Project	IEEE 802.16 Broadband Wireless Access Working Group < http://ieee802.org/16 >	
Title	Modification on Relaying DCD and UCD	
Date Submitted	2007-07-05	
Source(s)	Kanchei (Ken) Loa, Yi-Hsueh Tsai, Yung-Ting Lee, Hua-Chiang Yin, Shiann-Tsong Sheu, Youn-Tai Lee, Institute for Information Industry 8F, No. 218, Sec. 2, Dunhua S. Rd., Taipei City 106, Taiwan	Voice: +886-2-27399616 Fax: +886-2-23782328 loa@nmi.iii.org.tw
Re:	IEEE 802.16j-07/019: "Call for Technical Comments Regarding IEEE Project 802.16j"	
Abstract	This contribution proposes modification on relaying DCD and UCD	
Purpose	Text proposal for 802.16j Baseline Document.	
Notice	<i>This document does not represent the agreed views of the IEEE 802.16 Working Group or any of its subgroups. It represents only the views of the participants listed in the "Source(s)" field above. It is offered as a basis for discussion. It is not binding on the contributor(s), who reserve(s) the right to add, amend or withdraw material contained herein.</i>

Modification on Relaying DCD and UCD

Proposed text change

Figure xxx –Relaying DCD/UCD procedure

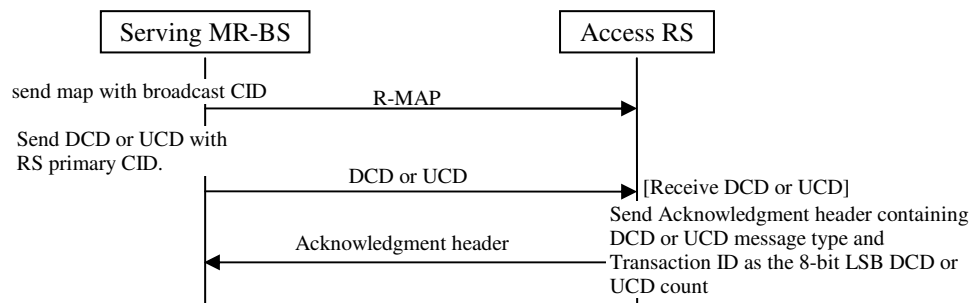
Upon receiving the DCD/UCD message with RS primary CID, as shown in Figure xxx, the RS should send acknowledgment header containing DCD or UCD message type and Transaction ID as the 8-bit LSB DCD or UCD count to MR-BS. Under centralized scheduling, as shown in Figure yyy, the RS shall request bandwidth on the access link to broadcast the DCD/UCD message with fragmentable broadcast CID. Under distributed scheduling, the RS shall autonomously broadcast DCD/UCD on the access link.
